Access Compliance Report

Public Rights-of-Way (Curb Ramps)

Intersection ID: 5946	Main Street: CONIFER_CR	Cross Street: FAIRES_FARM_RD	Location:	N
ADA ID: 4CF5F5478807	Ramp Type: Perp	Initial Pass/Fail: Fail	Overall Compliance: No	Severity Score: 21.25
Codes/Mitigation Info/Possible Solution		Field Measurements/Component Compliance

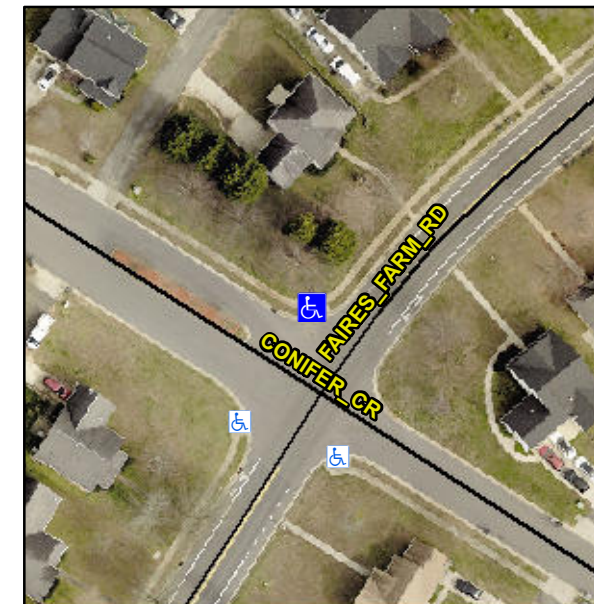
Not Found, R304.5.1, R304.2.2

Compliance	Description	Data	Compliance	Description	Data
N/A	Ramp Length (in)	47.5	No	Ramp Slope (%)	9.9
No	Ramp Width (in)	46.5	Yes	Ramp XSlope (%)	0.5
N/A	Flare Type LT	N/A	N/A	Flare Type RT	N/A
N/A	Flare Slope LT (%)	N/A	N/A	Flare Slope RT (%)	N/A
N/A	Flare Traversable LT?	N/A	N/A	Flare Traversable RT?	N/A
N/A	Landing Length (in)	N/A	N/A	DWS Provided?	N/A
N/A	Landing Width (in)	N/A	N/A	DWS Contrast?	N/A
N/A	Landing Slope (%)	N/A	N/A	DWS Length (in)	N/A
N/A	Landing X Slope (%)	N/A	N/A	DWS Full Width?	N/A
N/A	Landing Curb? (Y/N)	N/A	N/A	DWS Offset (in)	N/A
N/A	Shared Landing?	N/A			
N/A	Gutter Ponding?	N/A	N/A	Gutter Slope (%)	N/A
N/A	Gutter Lip Ht (in)	N/A	N/A	Gutter X Slope (%)	N/A
N/A	Painted X Walk1?	No	N/A	Painted X Walk2?	N/A
	X Walk 1 Direction	To W		X Walk 2 Direction	N/A
N/A	X Walk 1 Width (in)	N/A	N/A	X Walk 2 Width (in)	N/A
	X Walk 1 Slope (%)	0.8		X Walk 2 Slope (%)	N/A
	X Walk 1 X Slope (%)	0.5		X Walk 2 X Slope (%)	N/A

Remove & Replace Entire Ramp.
